BASIC INFORMATION	
Title and GS reference number of the project activity	Production and dissemination of Ceramic Water Purifiers by Hydrologic, in the Kingdom of Cambodia Reference number of the project Activity: GS1020
Scale of the project activity	<input checked="" type="checkbox"/> Large-scale <input type="checkbox"/> Small Scale
Version number of the verification and certification report	1.2
Completion date of the verification and certification report	25/06/2024
Monitoring period number and duration of this monitoring period	Monitoring Period: 6 th Monitoring duration: 01/01/2023- 31/12/2023 (including both the dates)
The version number of the monitoring report to which this report applies	Version 2.4, Dated :21/06/2024
The crediting period of the project activity corresponding to this monitoring period	CP2: 01/12/2017 to 30/11/2024 (both days included) (Twice Renewable CP)
Project participants	Hydrologic Social Enterprise Ltd.

Name and UNFCCC reference number of theVVB	E-0052: Carbon Check (India) Private Ltd.
Name, position and signature of the approverof the verification and certification report	 Priya Suman, Compliance Officer

SECTION A. Executive summary

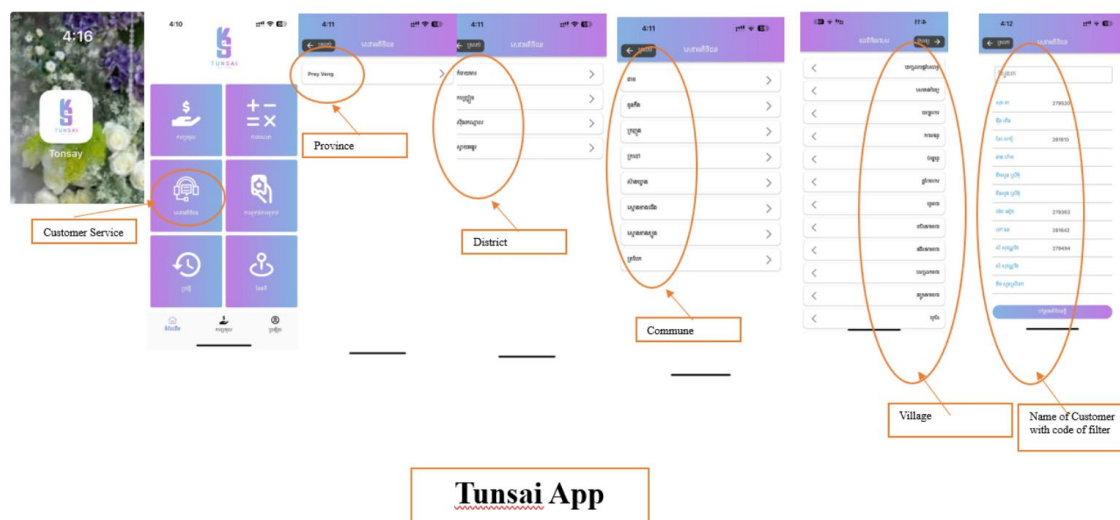
CL ID	01	Section no.	B.1.1	Date: 09/05/2024
Description of CL				
VVB reviewed the MR and found that the PP has addressed the FAR raised during third MP, however, it is not clear to the VVB that how the data ceramic filter replacement data is tracked and recorded. PP shall clarify the procedure in place to track the filter replacement and share the sample records.

The data ceramic filter replacement is tracked and recorded in Tunsai App by sale team as shown in the below screenshot. It should be noted that the sale team who are working on the ground could receive the information for pot replacement from two main channels: hotline channel and their own sale channel. The replacement can be free of charge if it is still under warranty period (2 years) otherwise, it is charged as spare part item.

The VVB acknowledges the clarification provided by the PP regarding the tracking and recording of ceramic filter replacement data. The explanation that the data is recorded in the Tunsai App by the sales team, along with the provided screenshot, is satisfactory. The process of receiving replacement information through the hotline and sales channels is well-documented.

Based on the provided evidence, explanation and OSV observation, the VVB considers the clarification adequately addressed and closed.

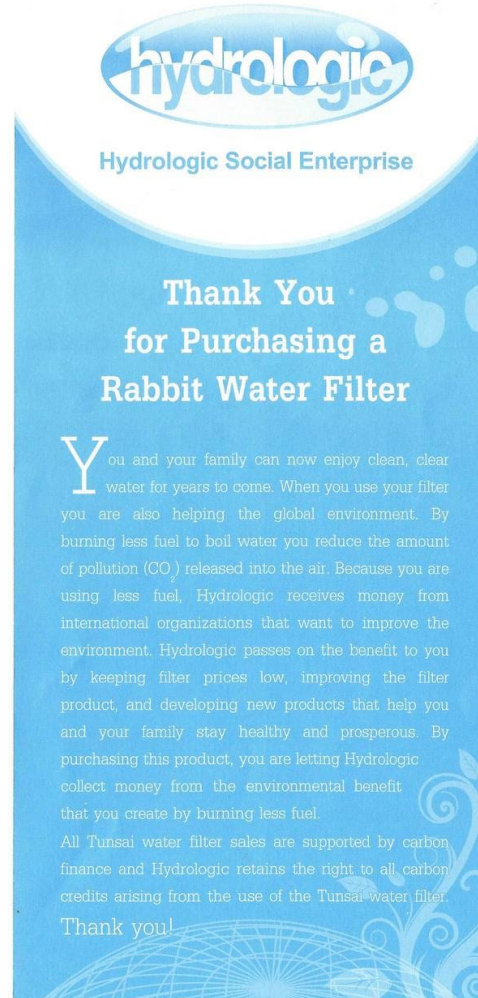
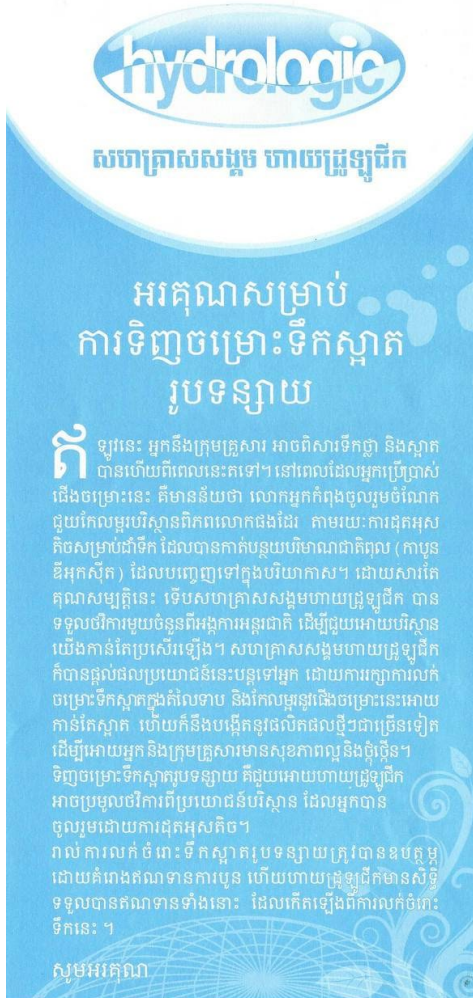
CL ID	03	Section no.	onsite findings	Date: 16/05/2024
Description of CL				
During onsite interviews, VVB found some of the stakeholders denied signing Carbon right transfer form, PP shall clarify.				
Project participant response				Date: 24/05/2024

This might be a confusion as PP has never asked stakeholder to sign carbon right transfer form but PP has notify them with a written thank you note “All Tunsai water filter sales are supported by carbon finance and Hydrologic retains the right to all carbon credits arising from the use of the Tunsai water filter” that come with a package when user purchases any filter unit, as seen below.

Furthermore, this is also in line with the registered PDD (page 12) “PP clearly communicated to the stakeholder that PP will claim ownership rights at the stakeholder consultation. In addition, PP is including a document in every water filter sold that explains that PP retains the rights of ownership of the GHG reductions”.

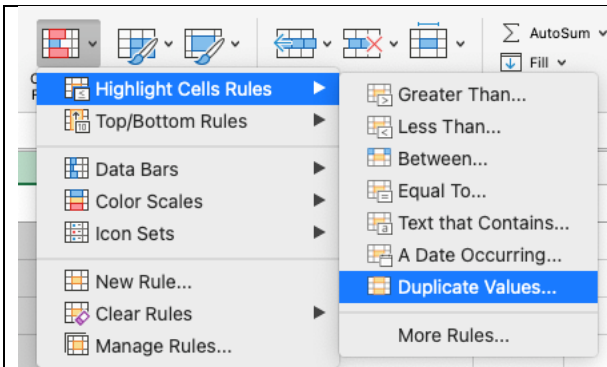
VVB reviewed the MR, training documents and found that the PP has addressed the FAR raised for the data duplication during 5th MP, however, PP shall submit the attendance records, training photographs, and list of employees trained on the subject for avoidance of duplicate entry of the records. Further, PP shall elaborate the specific record for which measure has been taken in the worksheet for the automated checking column to alert if the information is duplicated.

The minute of the refreshing training on data duplication is submitted. To set an automatically check if the name of users in the project database are duplicated or not, PP has combined the name of user with their address (village and commune) as a unique ID of each user. Then, a function of “conditional formatting of Microsoft Excel” is used to track duplicated cells. Please refer to “column M of the attached project database for the detail formula.
